NUCLEAR DIAGNOSTICS, INC.

February 21, 1985

Re: Nuclear Diagnostics, Inc.
Control No. 77914

The purpose of this letter is to: (a) respond to the ten items that needed clarification per your letter of February 7, 1985, (b) add George Ade Memorial Hospital to our application, and (c) add Sangarappillai Asokan, M.D., as a user on our license.

Cole Hospital
Champaign, Illinois Room Utilized For Nuclear Medicine.

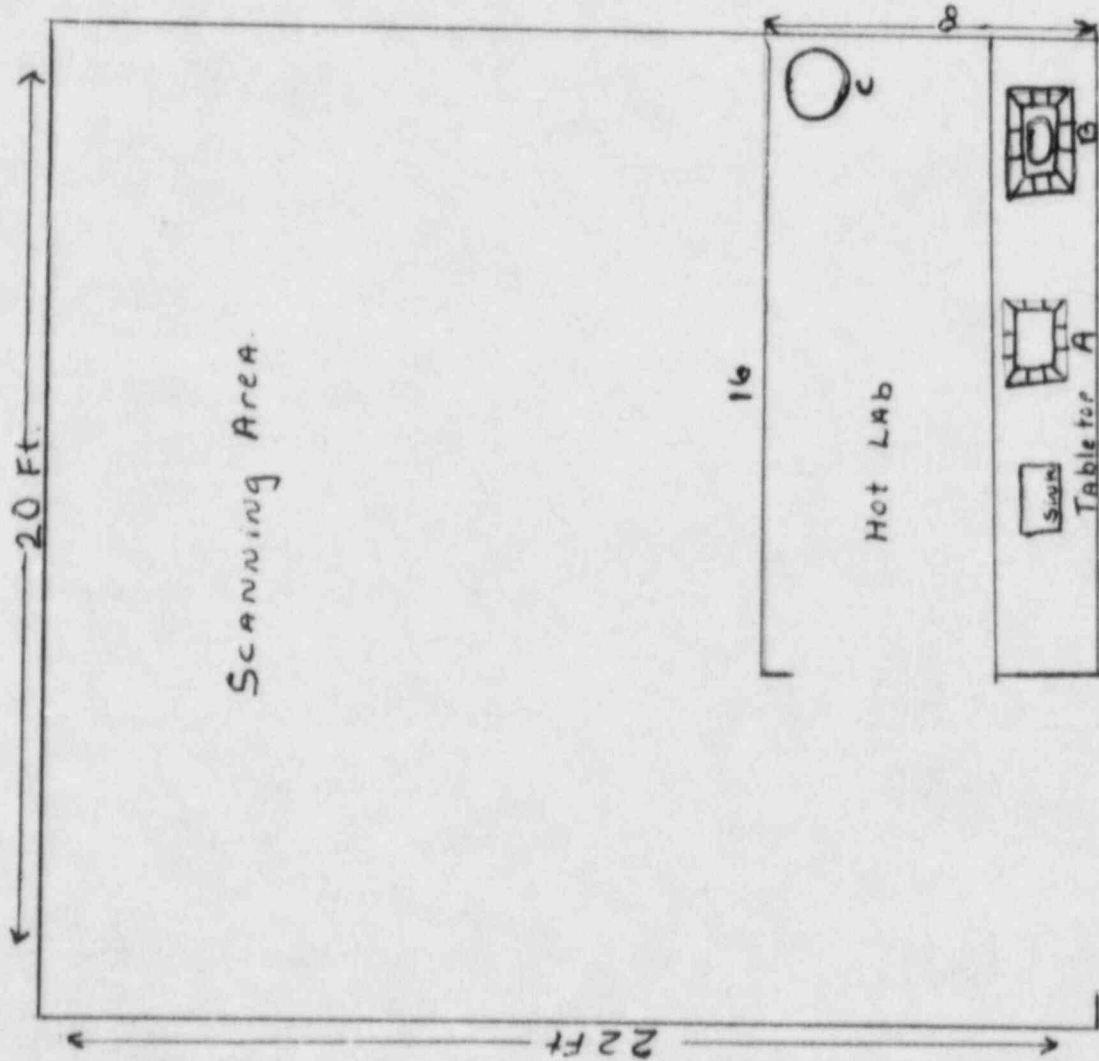
- a. Nuclear Medicine technologist will have control over entries to areas where scanning procedures are being performed. In addition, warning signs will be posted at room entry points stating "Caution Radioactive Material" Do Not Enter.
- b. Our intention was to have Cole Hospital donate this specific area to NDI. NDI would then be totally responsible for the administrative action of that room. NDI personnel, and not Hospital personnel, will receive, store and remove all radioactive material. Only NDI personnel will have use of that room. Under separate cover you will receive a statement from Robert H. Pierce, Administrator, Cole Hospital, clarifying the idea that they would relinquish the sole administrative responsibilities of said room to NDI.
- c. Enclosed is a diagram of the area where our hot lab will be located.

A. Location for drawing doses. Bricks will be 2x4x8
The overall structure will be- 20" in length, 16" deep,
and 8" high.

B. Generator; Bricks used- 2x4x8. The structure will be
20" wide, 16" deep, and 16" high.

C. Storage container

2. The areas monitored, to be read at or below 0.05 mr/hr, will be the following;

- a. scanning area
- b. hot lab
- c. hallway
- d. file room

NDI personnel will be the only people with access to the
Nuclear Medicine room. The hospital security will have keys
to the room, however to be used for emergency purpose only.
